## Arrangements of the module mark in combination with an approval mark

Current examples given to be deleted and replaced by the following:

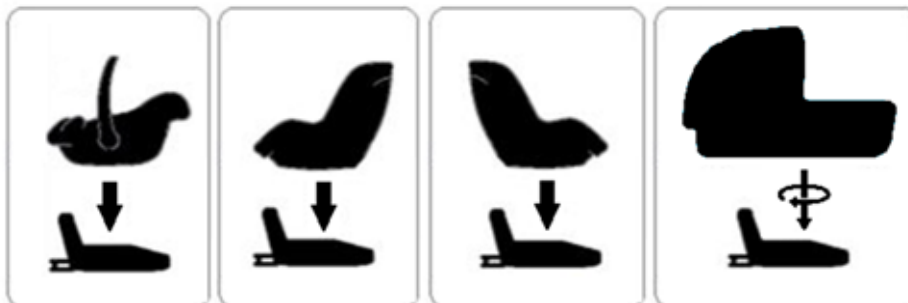
The Enhanced Child Restraint System module bearing the above module mark capable of being used for the 40 cm – 70 cm size range and mass limit of 24 kg; it is approved under the number 022439 to be used in combination with device approved according to UN Regulation No. 129 under the same number 022439. The approval number indicates that the approval was granted in accordance with the requirements of the Regulation concerning the approval of Enhanced Child Restraint Systems used on board of motor vehicles as amended by the 02 series of amendments

The Enhanced Child Restraint System module bearing the above module marks is capable of being used in a rearward facing mode with the base "brand name and model name", for the ~~85~~60 cm - 105 cm size range and with a mass limit of 18 kg; approved according to UN Regulation No. 129-02 under the number 022441.

The Enhanced Child Restraint System module bearing the above marks is also capable of being used in a forward facing mode with the base "brand name and model name", for the 85 cm - 105 cm size range and with a mass limit of 18 kg; approved according to UN Regulation No. 129-02 under the same number 022441.
